Pilot Region-Based Optimization Program for Fund-Lead Sites in EPA Region 3

Site Optimization Tracker: Raymark Hatboro, Pennsylvania

RAYMARK SUPERFUND SITE HATBORO, PENNSYLVANIA

Report of the Remediation System Evaluation,
Site Visit Conducted at the Raymark Superfund Site
June 7-8, 2001

FIGURE 1-3. CROSS SECTION OF THE GEOLOGY UNDERLYING THE RAYMARK SITE.

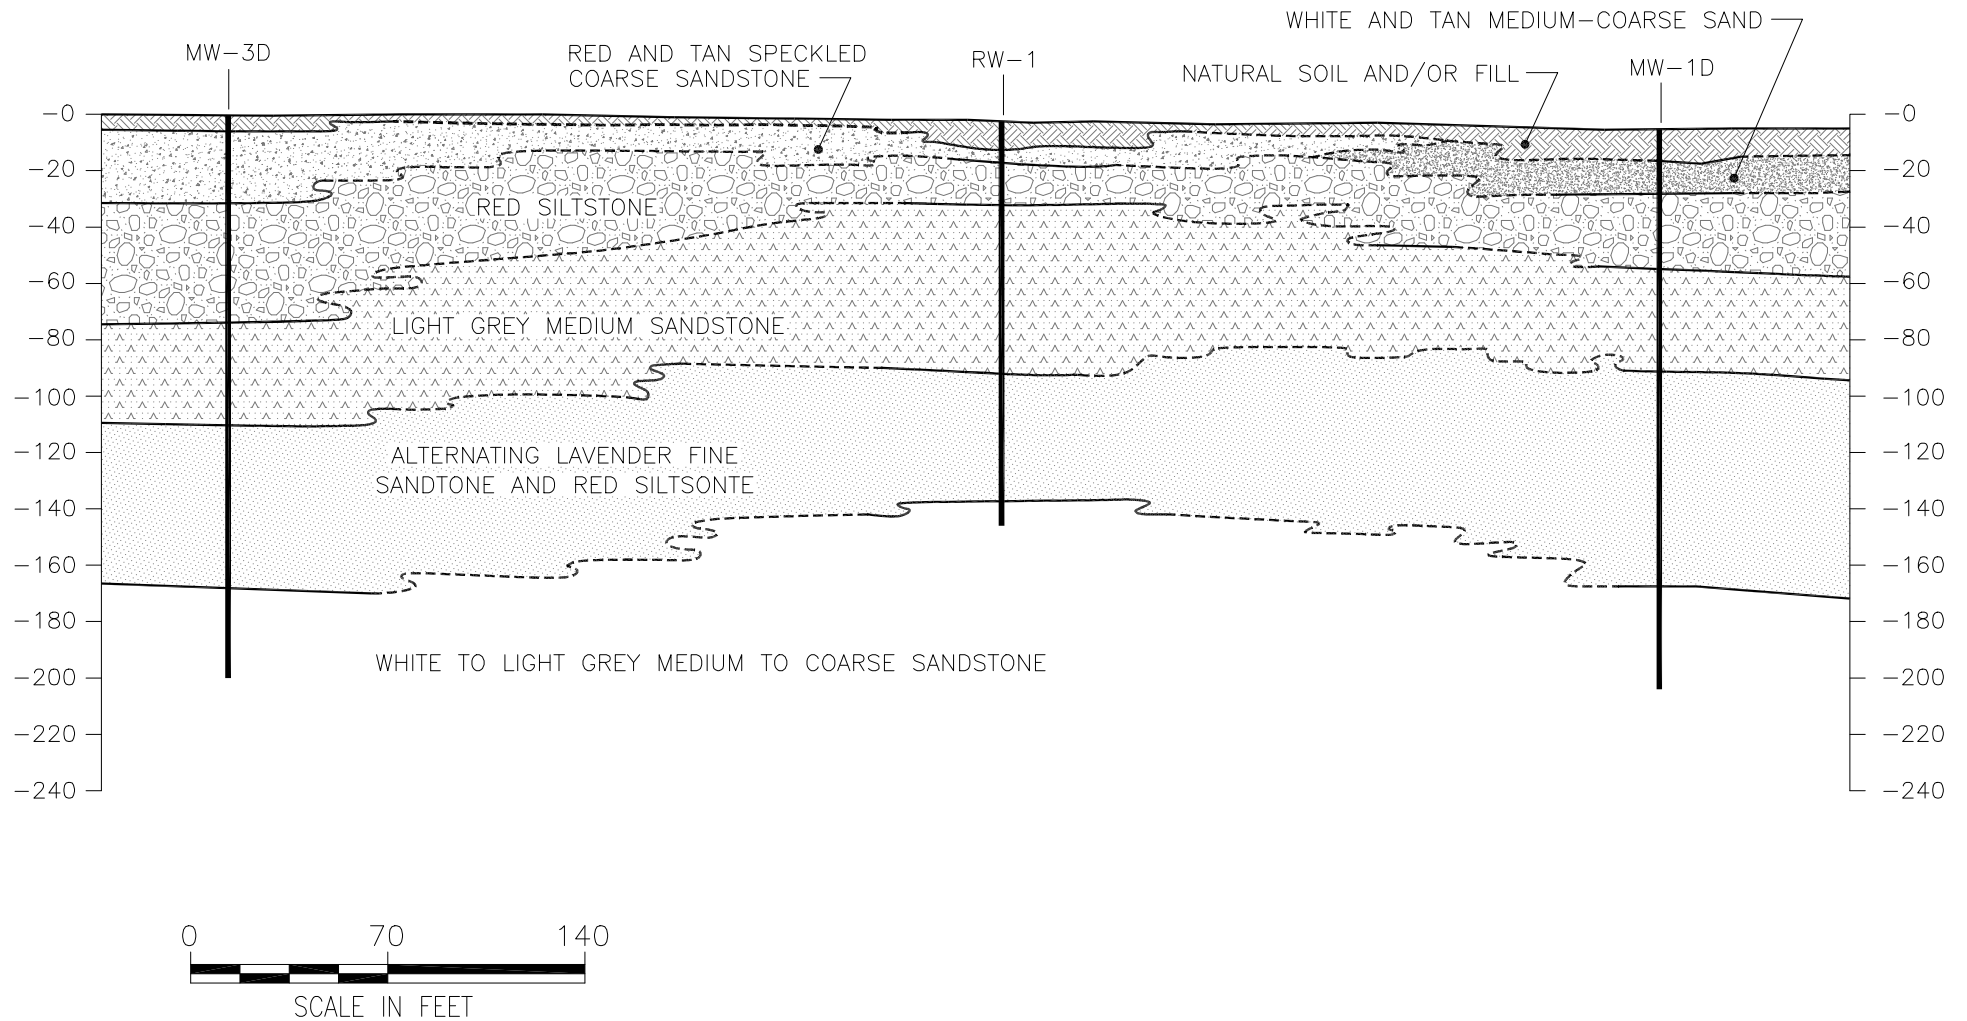
The extent of ground water TCE contamination onsite should be further investigated as well, especially along the site boundaries. A cluster of sampling points each independently screening the stratigraphic units shown in Figure 1-3 and located midway between the MW-3 and MW-2 clusters would help delineate the plume on the western boundary of the site. This is significant given that ground water likely flows to the west toward Pennypack Creek and Hatboro wells H-14 and H-17. Another cluster of sampling points each screening the stratigraphic units shown in Figure 1-3 and located midway between the MW-3 cluster and the rear end of the property (to the east) would help delineate the plume on the southern/western site boundary. This is also significant because Pennypack Creek turns and passes within a mile to the southwest of the site and ground water could be flowing in that direction. These points should be added to the annual sampling program and analyzed for volatile organic compounds (VOCs).
